Tube Disc Assembly Complete, 72.5mm

for Superba Winder, B400, B401, BLA

**IMPROVED
DESIGN**

Tube Disc Assembly Complete, 72.5mm for Superba Winder,
 Improved Design
 OEM: (730-142-523)

EE130015

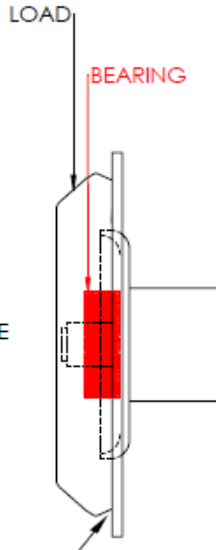
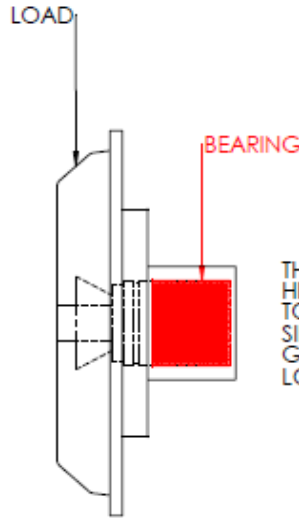
THE TORQUE / MOMENT FORCE ON THE BEARING IS DECREASED ON THE NEW DESIGN, SINCE THE BEARING IS NOW LOCATED DIRECTLY UNDERNEATH THE LOAD OF THE PACKAGE

RECESS PROVIDES BETTER RETENTION OF THE TUBES WITH WORN ENDS.

THE OLD DESIGN ALLOWS A HIGH TORQUE / MOMENT FORCE TO BE EXERTED ON THE BEARING, SINCE THE BEARING IS LOCATED A GREATER DISTANCE AWAY FROM THE LOAD OF THE PACKAGE
